1978 Corvette: Service Bulletin: Removable Roof Panel Fit

Subject: Removable Roof Panel Fit

Bulletin No: 78-T-23

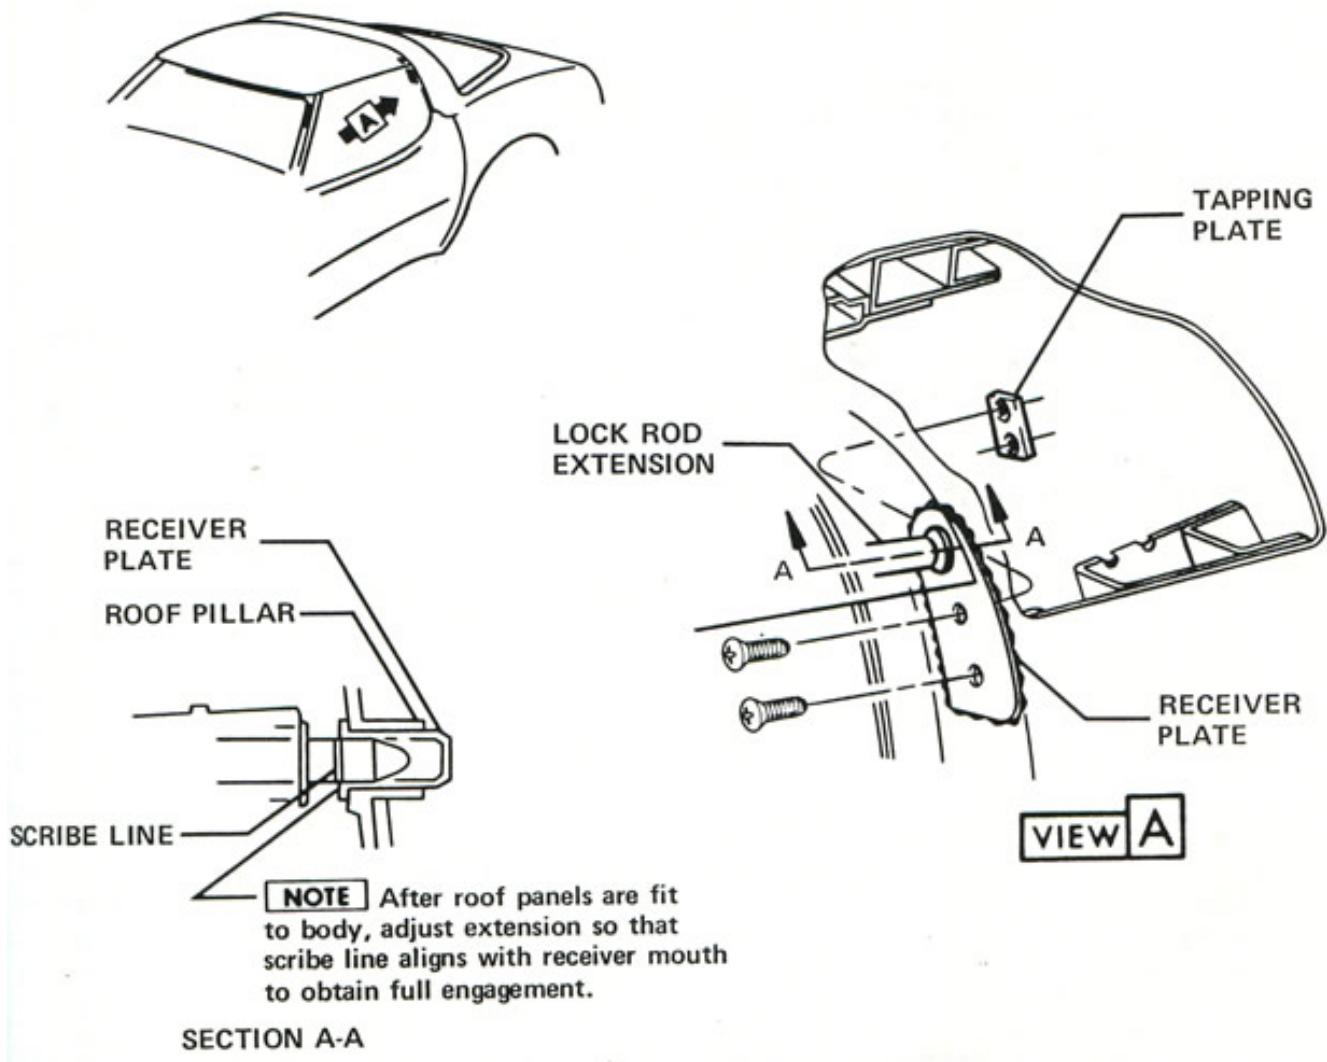
Some early 1978 Corvette removable roof panels may be bowed in relation to the windshield header and/or rear roof. This condition can be caused by an improperly positioned roof lock receiver plate.

The bow in a roof panel can be eliminated by lowering the roof lock receiver plate as outlined below:

1. Remove the rear roof corner garnish and lower roof trim panel.
NOTE: It is not necessary to remove the shoulder belt or retractor.
2. Remove the roof lock receiver plate screws. Hold the tapping plate, located behind the roof pillar, to prevent it from falling (see illustration on page 2). Remove any excess sealer from pillar and receiver plate.
3. Using a small round file, elongate (lower) the three holes in the roof pillar as required to obtain a relaxed roof panel with a flush fit. This will be a trial and error process of installing the receiver plate and checking that the roof panel lock rod extension engages easily.

4. When an acceptable roof panel fit is achieved, thoroughly pack the area behind the receiver plate with 3M Strip-calk or equivalent.
5. Reinstall interior trim panels.
6. Adjust the door glass to the roof weatherstrip as described in Section 2D, 1978 Service Manual.
